Subject: S. 16 Planning Application No. A/YL-KTN/1254 - Departmental Comments

S. 16 Planning Application No. A/YL-KTN/1254 - Departmental Comments

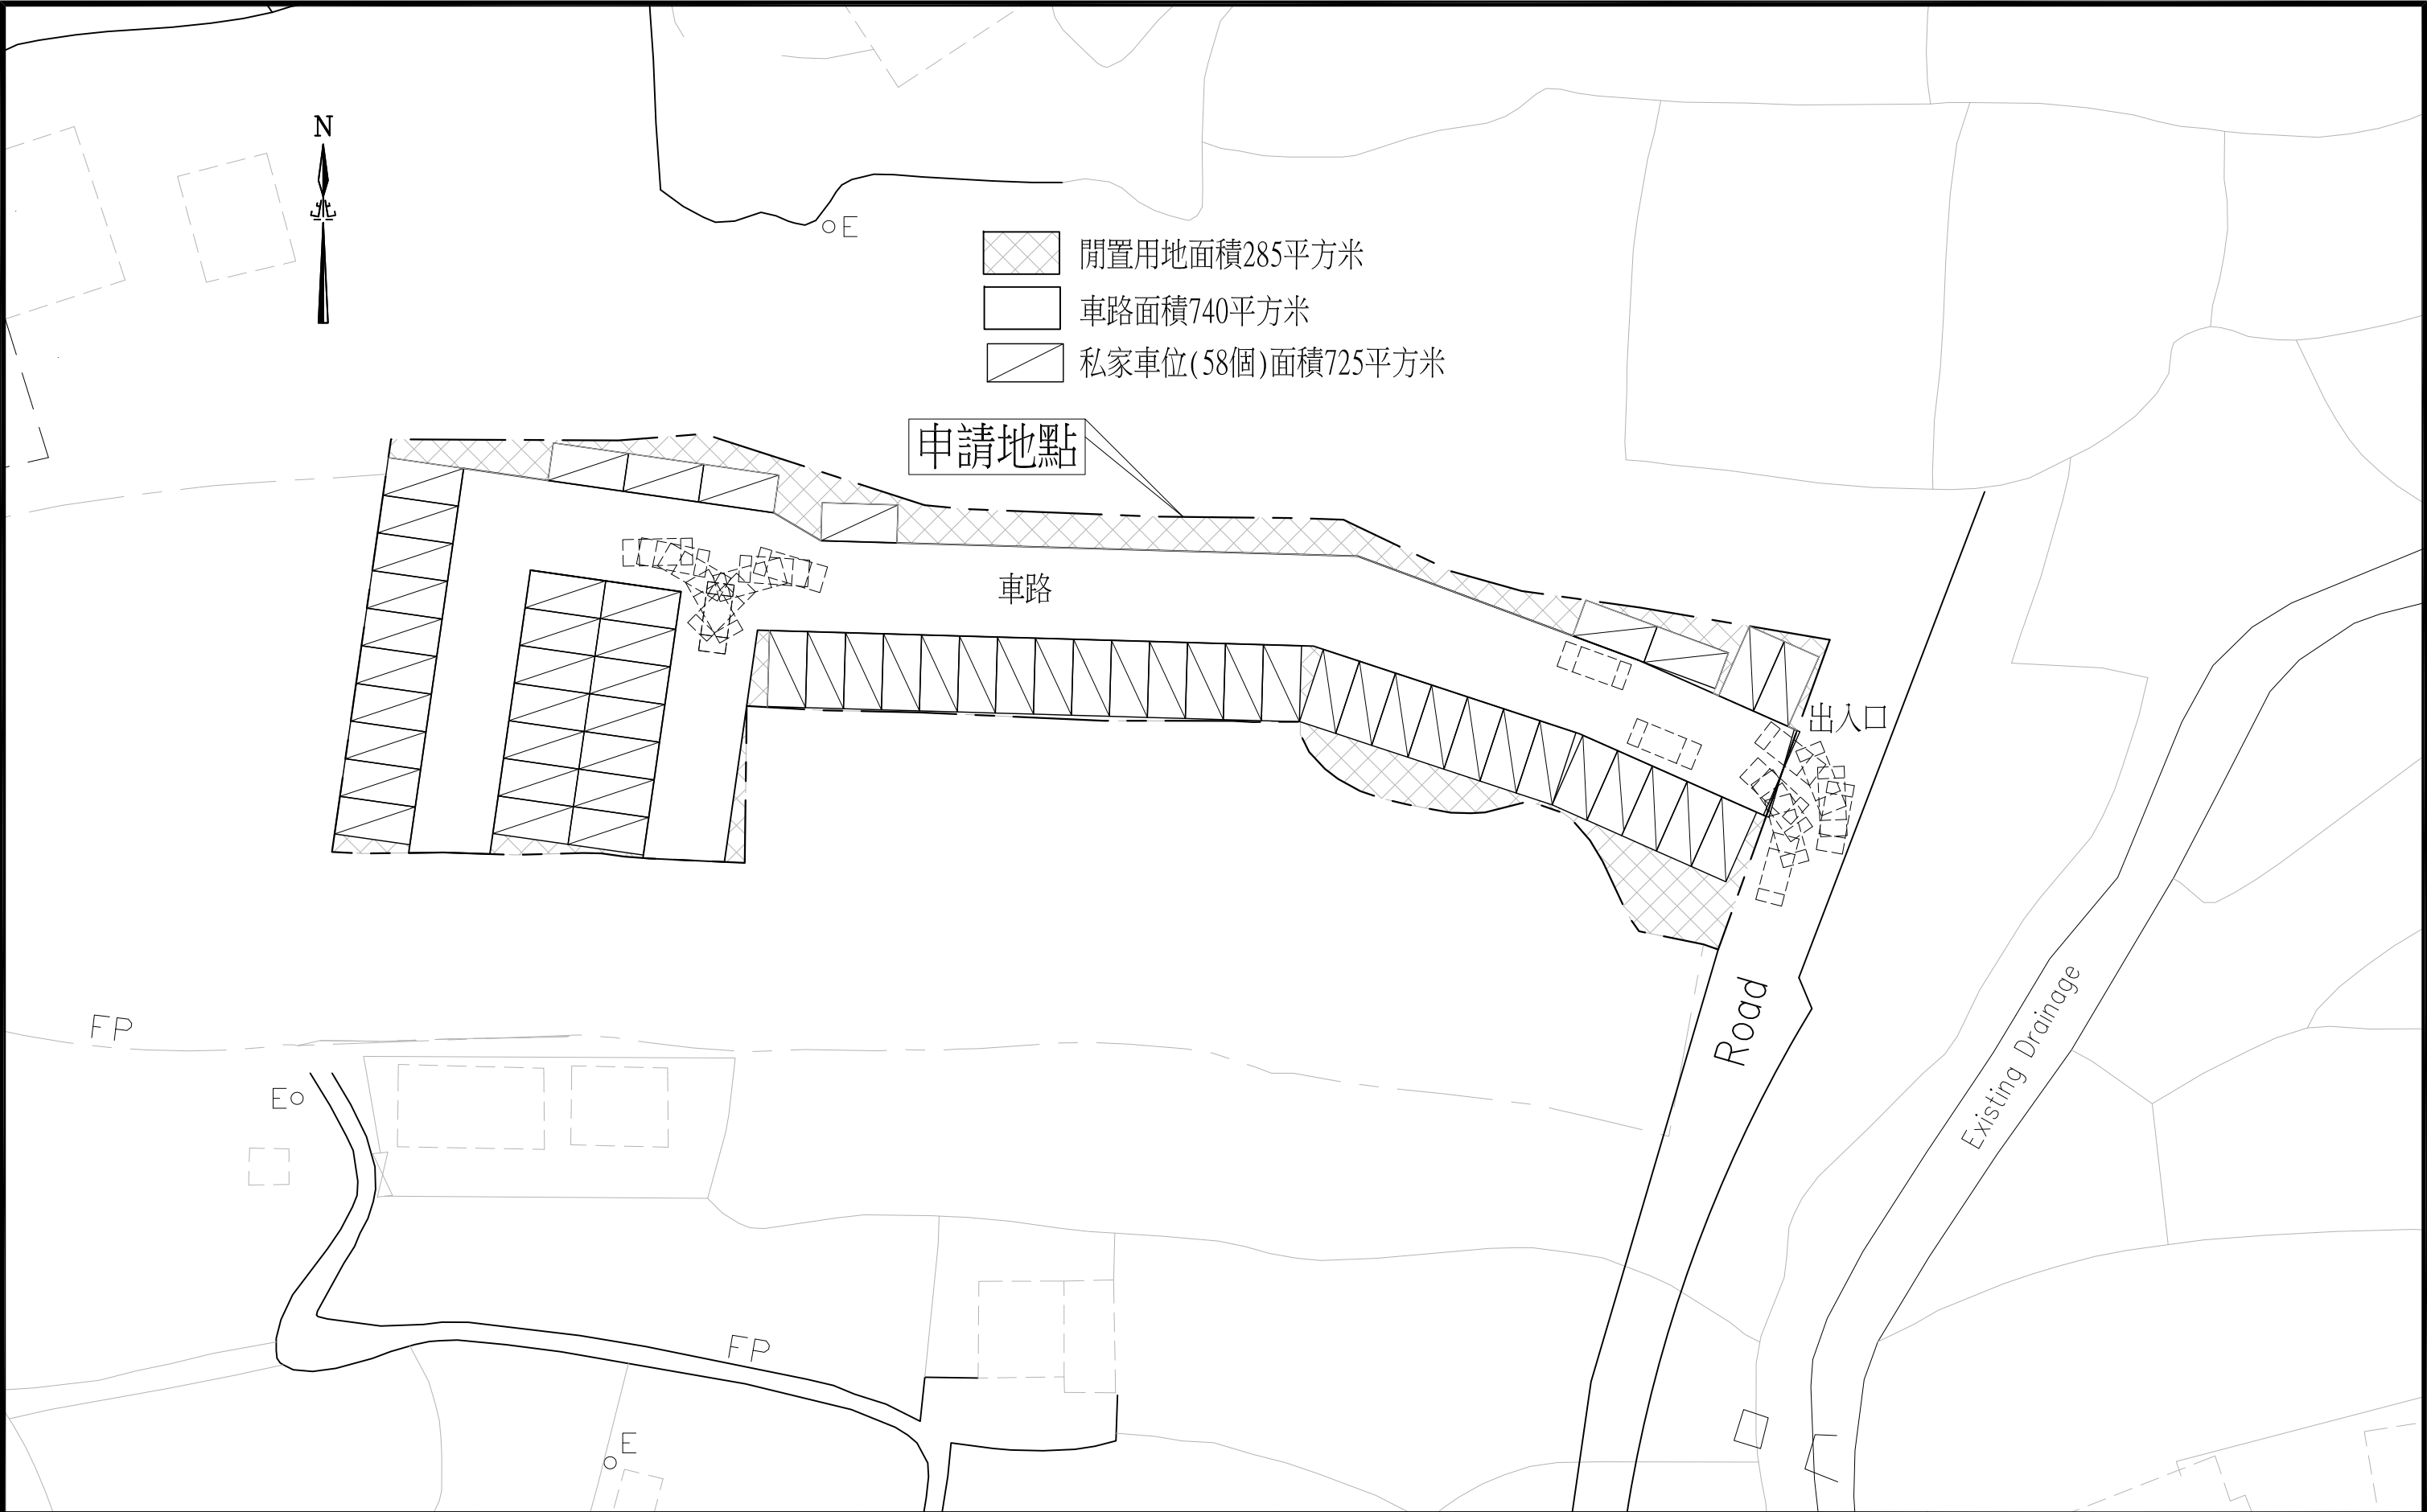
Below please find the comments of the Transport Department (Contact: Mr. Phil CAI at 2339 2421).

a. The applicant should provide information on how to control the vehicles enter and leave the site at the same time, causing adverse traffic impact to the adjacent local access;	申請場地除了員工到申請場地取出停泊待售汽車外，場內只作靜態儲存，對附近交通不會構成壓力或交通阻塞。
b. The applicant should provide the trip generation and attraction due to the development and assess the traffic impact to Kong Tai Road and the local access;	申請地點車道有東面為申請地點出入口，闊度約 6 米，並連接現有行路直接接連江大路，車輛可以在場內調頭，不會阻塞交通或佔用場地以外地點作為上落貨物地點，不會對當地交通有影響。(行車路線圖)
c. The applicant should demonstrate the smooth manoeuvring of vehicles to / from Kong Tai Road, along the local access and within the site.	停車場只有泊車位，沒有上落客貨處，車輛不須以倒車方式進入，只在申請地點範圍內掉頭轉出，不會以倒車方式往(從)公用道路退出，沿當地現有道路行駛，均可暢順通行。(車輛迴旋軌跡圖)
